**LANDOWNER SUBMISSION: CASEY FIELDS SOUTH (EMPLOYMENT) & DEVON MEADOWS PSP  
235 CLYDE-FIVE WAYS ROAD, CLYDE 3978 (PARCEL CF-23)  
1665 SOUTH GIPPSLAND HIGHWAY, CRANBOURNE EAST 3977 (PARCEL CF-13)  
TITLE DETAILS: LOT 1 ON PS421555E & CP165660**

**LANDOWNER DRAINAGE SUBMISSION: CASEY FIELDS SOUTH (EMPLOYMENT) & DEVON MEADOWS PSP  
235 CLYDE-FIVE WAYS ROAD, CLYDE 3978 (PARCEL CF-23)  
1665 SOUTH GIPPSLAND HIGHWAY, CRANBOURNE EAST 3977 (PARCEL CF-13)  
TITLE DETAILS: LOT 1 ON PS421555E & CP165660**

**2) Comments on the GHD Preliminary Concept Drainage Strategy report dated 21<sup>st</sup> February 2025:**

**Figure 1:** GHD Preliminary Concept Drainage Strategy Plan (left) vs PSP Plan 6 layout (right) of CFS3/CF-RB-04

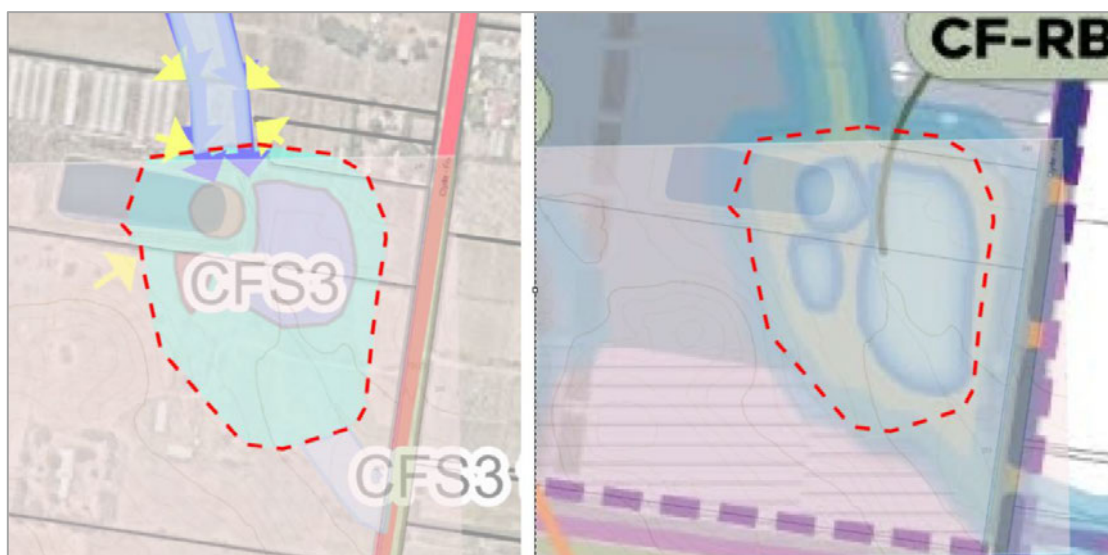
- a) MPG requests a detailed review of CFS3/CF-RB-04 by VPA and Melbourne Water to ensure this asset is optimised to suit the existing topography and future arterial road grading requirements. MPG is concerned that the extent of CFS3/CF-RB-04 drainage reserve shown in the draft PSP Plan 6 is significantly larger than shown in the GHD Preliminary Concept Drainage Strategy Plan (Appendix C) as shown in Figure 1 below:
  - i) There is a significant difference in CFS3/CF-RB-04 wetland area extent shown on PSP plan 6 (approx. 13,500m<sup>2</sup>) compared to the GHD report (9000m<sup>2</sup>).
  - ii) Additionally, the drainage reserve area shown in PSP Plan 6 appears to be significantly larger than shown in the GHD Concept design report (Appendix C). VPA needs to explain this discrepancy.

- b) MPG raise concerns regarding parameters used in the GHD report regarding CFS3/CF-RB-04 and request a thorough review of this asset by GHD, Melbourne Water and VPA:
  - i) MPG is particularly concerned that the GHD report, Table D4, indicates that the retarding basin is only 450mm deep, which exacerbates the retarding basin footprint requirement.
  - ii) MPG requests a retarding basin concept plan of this asset showing existing surface contours and typical cross sections to clarify the depth of the retarding basin and the assumptions made on the outlet. Consideration should be given to increasing the depth of the retarding basin to optimise and reduce the detention footprint.

- c) MPG would like the opportunity to work proactively with VPA and Melbourne Water to optimise the size and layout of CFS3/CF-RB-04. We suggest investigating opportunities to increase the detention depth, reduce detention footprint and delineate a more rectangular shape fronting Clyde-Five Ways Road to ensure an efficient development interface. It is our view that the preliminary concept layout of this asset has ample scope to optimise the shape and reduce land take requirements.

**Figure 2:** Galileo proposal to rationalise Retarding Basins CF-RB-02 and CF-RB-05

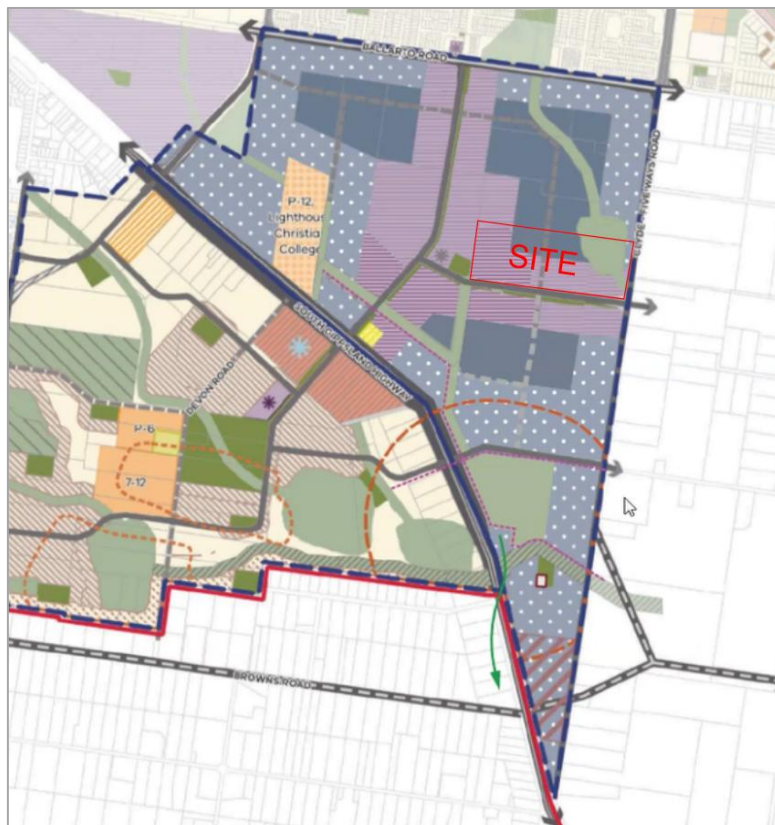
- a) MPG has concerns regarding the GHD concept design and flow management of these assets:
- CFS2/CF-RB-02 appears superfluous and should be integrated with CFS4/CF-RB-05 into a single regional drainage scheme asset for cost-efficiency.

- a) MPG is supportive of Galileo's proposal shown in Figure 2 below, which shows the full removal of SFC2/CF-RB-02 from the subject land. MPV's view is that Galileo's proposal, in the form shown in Figure 2, rationalises the drainage assets and increases the development potential of the overall precinct. Additionally, Galileo's proposal addresses some of the MPG concerns outlined in item 4 above regarding retarding basins CFS2/CF-RB-02 and CSF4/CF-RB-05.
